Airworthiness Directive Issuance Form

民航局 AD 編號 AD number	CAA-2023-05-012	發布日期 Date issued	2023/6/17
適用之航空產品 Applied to (models, serial numbers or part numbers, as applicable)	This AD applies to all transport and commuter category airplanes equipped with a radio (also known as radar) altimeter. These radio altimeters are installed on various transport and commuter category airplanes including, but not limited to, the airplanes for which the design approval holder is identified in paragraphs (c)(1) through (18) of this AD. (1) The Boeing Company (2) Airbus SAS (3) Bombardier Inc. (4) Embraer S.A. (including type certificates previously held by Yaborã Indústria Aeronáutica S.A., which are now held by Embraer S.A.) (5) Gulfstream Aerospace Corporation (6) Gulfstream Aerospace LP (7) Textron Aviation Inc. (8) Pilatus Aircraft Limited (9) Fokker Services B.V. (10) Saab AB, Support and Services (11) DeHavilland Aircraft of Canada Limited (12) Airbus Canada Limited Partnership (13) ATR-GIE Avions de Transport Régional (14) MHI RJ Aviation ULC (15) BAE Systems (Operations) Limited (16) Lockheed Martin Corporation/Lockheed Martin Aeronautics Company (17) Viking Air Limited (18) Dassault Av

Figure 1 to paragraph (g)(1)(i)— *Fundamental Effective Isotropic PSD at Outside Interface of Airplane Antenna*

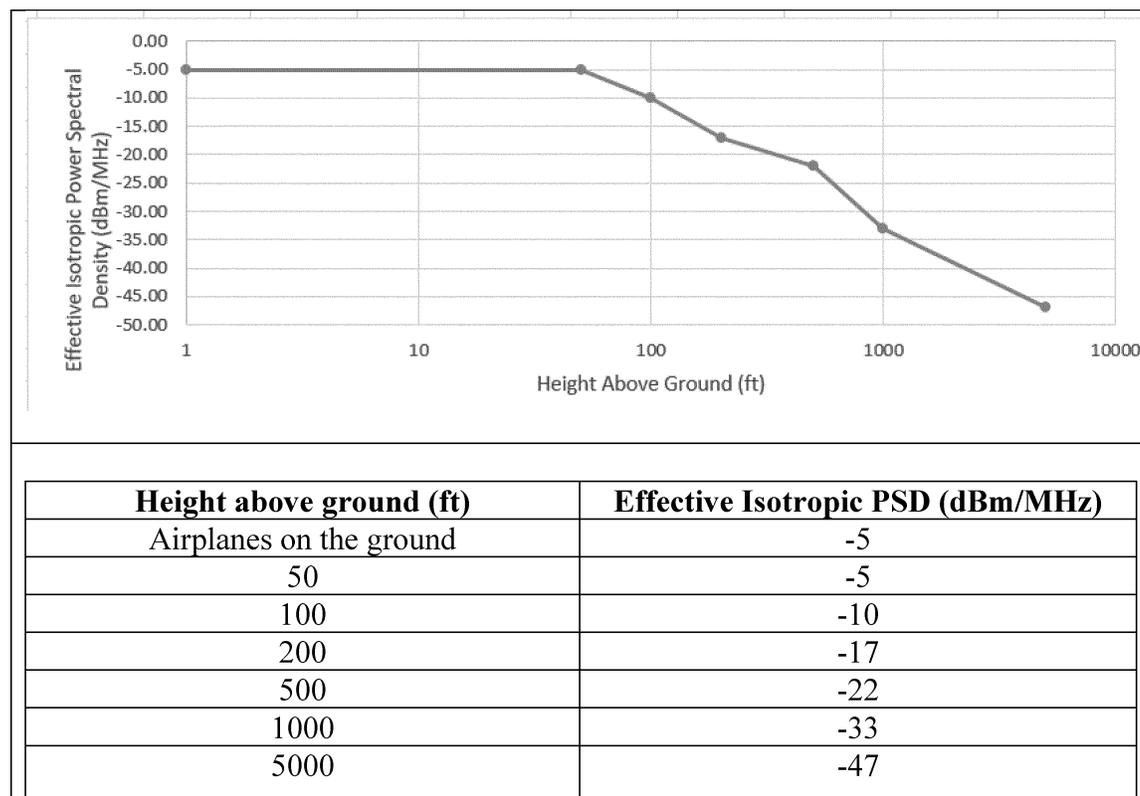
Comment summary: Textron Aviation requested the FAA clarify at what reference point the PSD requirements apply. The commenter stated it assumed that they apply at the radio altimeter receive antenna input, such that antenna characteristics, coax loss, and filter characteristics would be included in the determination.

Comment summary: Airbus and Bombardier requested that the FAA revise the table at the bottom of the proposed PSD curve to add the limit for 2500 feet above ground level. The commenters stated that this would be consistent with the maximum operating range of popular radio altimeter models installed on many airplanes and would avoid extrapolation errors.

Comment summary: Thales requested that the radio altimeter performance criteria specified in

figure 1 to paragraph (g)(2) of the proposed AD be revised to explicitly cover any 5G emitter station up to 65 dB/MHz in the applicable 3.7–3.98 GHz band.

FAA response: The FAA agrees and has changed the title of figure 1 to paragraph (g)(1)(i) of this AD to reflect that the PSD requirements apply at the antenna input to the radio altimeter, and that the figure applies to the outward facing side of the antenna.

FAA response: The FAA disagrees. The FAA developed the PSD curve to cover all transport and commuter radio altimeters and has determined that any extrapolation errors are sufficiently small and will not affect compliance or compromise safety.

Figure 2 to paragraph (g)(1)(ii)— *Spurious Effective Isotropic PSD at Outside Interface of Airplane Antenna*

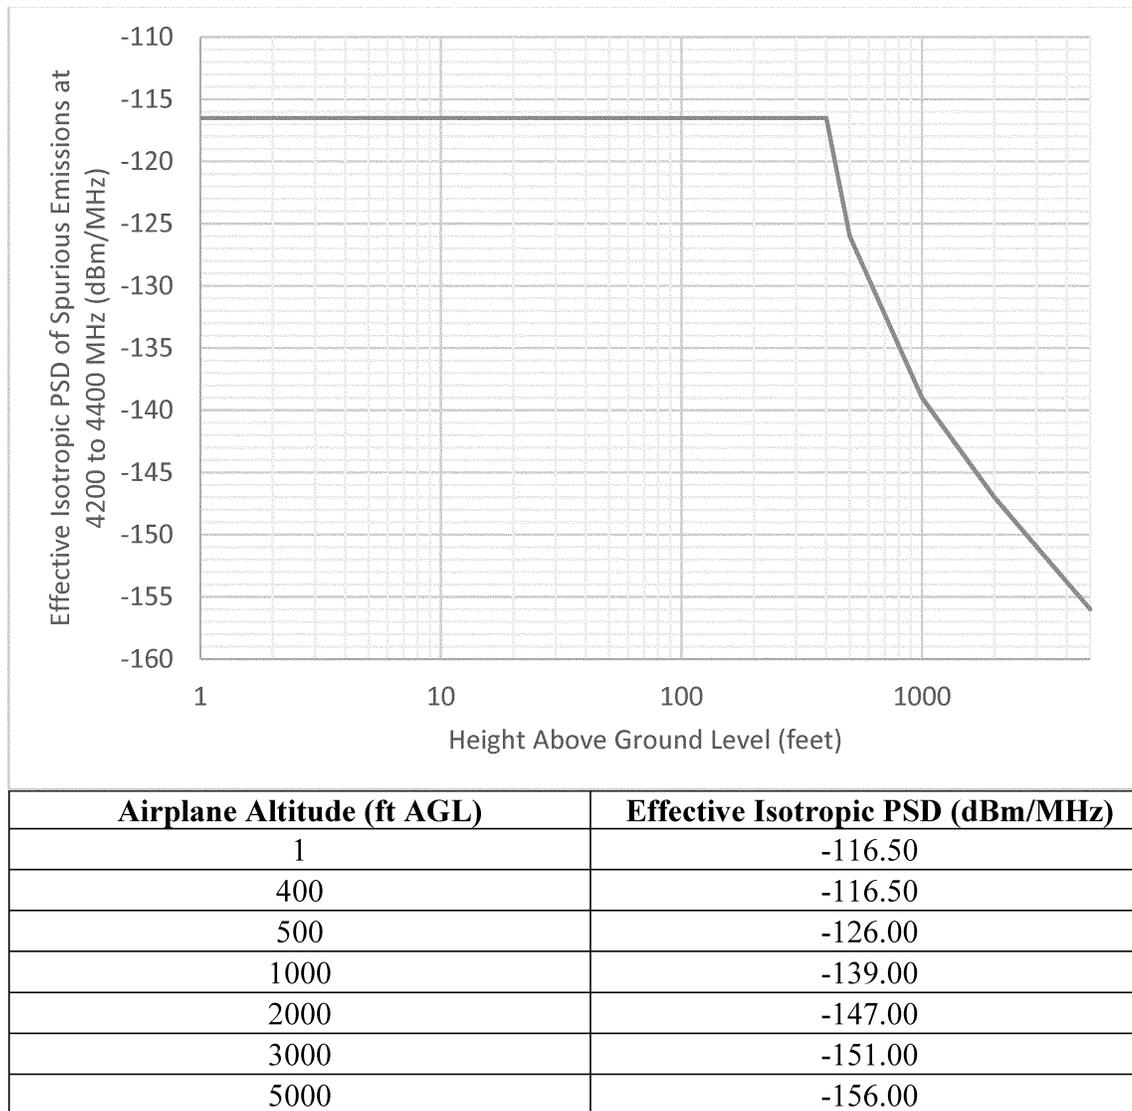
Comment summary: AIA requested that the FAA provide more information about the tolerances for determination of whether an airplane is radio altimeter tolerant. Several commenters requested

that the FAA add a new figure indicating the spurious tolerance, similar to the figure with the PSD tolerance curve, and a specification of the altitude dependence for spurious tolerance.

FAA response: The FAA agrees and has replaced the proposed fixed emission level with a spurious PSD tolerance curve in figure 2 to paragraph (g)(1)(ii) of this AD. Subsequent figures have been redesignated accordingly.
